MANDATORY SERVICE BULLETIN

DATE: December 18, 1990
Service Bulletin No. 411B
(Supersedes Service Bulletin No. 411A)
Engineering Aspects are
FAA Approved

SUBJECT: Adapter Kit for Magneto Isolation Drive

Magneto Drive and Component Parts

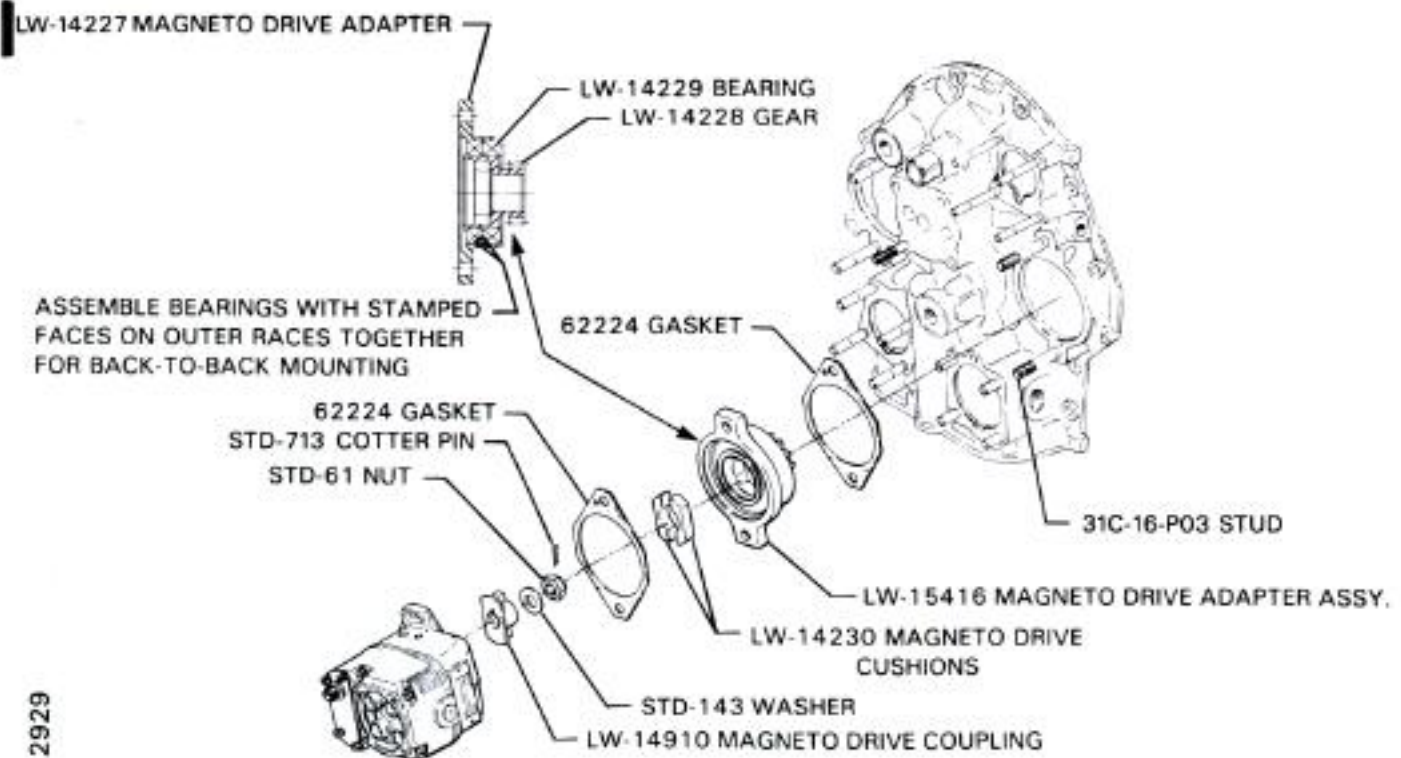
To provide a more maintenance free magneto drive system, a new magneto drive adapter and rubber cushion has been designed to isolate the magneto from the vibratory forces that could be transmitted by the driving components. This product improvement has been introduced in both new and remanufactured engines with serial number and date as shown above.

Also, a modification kit is now available for field installation as described in the following procedure. Note that this modification consists of removing the right magneto, replacing the attaching studs in the accessory housing and replac-

ing the drive components of the magneto as shown in the illustration.

1. Remove the right magneto and the attaching studs in the accessory housing.
2. Install the two (2) P/N 31C-16-P03 studs in the accessory housing. The correct driven height of these studs is 1.34/1.38 inch.
3. Place a new P/N 62224 gasket over the studs on the magneto mounting pad in the accessory housing. Then install P/N LW-15416 magneto drive adapter over the studs.
4. Remove the cotter pin, nut, washer and drive gear from the magneto drive shaft.
5. Clean the magneto shaft with a cloth wetted with methyl-ethyl ketone or clean unleaded gasoline. Dry thoroughly and apply a light coat of Go Jo No Lok

No. 72 compound to the tapered portion of the magneto shaft.

6. Install the P/N LW-14910 magneto drive coupling on the magneto shaft; then reassemble the washer and nut removed in step 4. Tighten the nut to 20/25 ft. lbs. torque and secure the nut with a new P/N STD-713 cotter pin.

7. Install two P/N LW-14230 drive cushions in the P/N

LW-15416 magneto drive adapter, then place a P/N 62224 gasket over the studs against the adapter and reassemble the magneto on the engine.
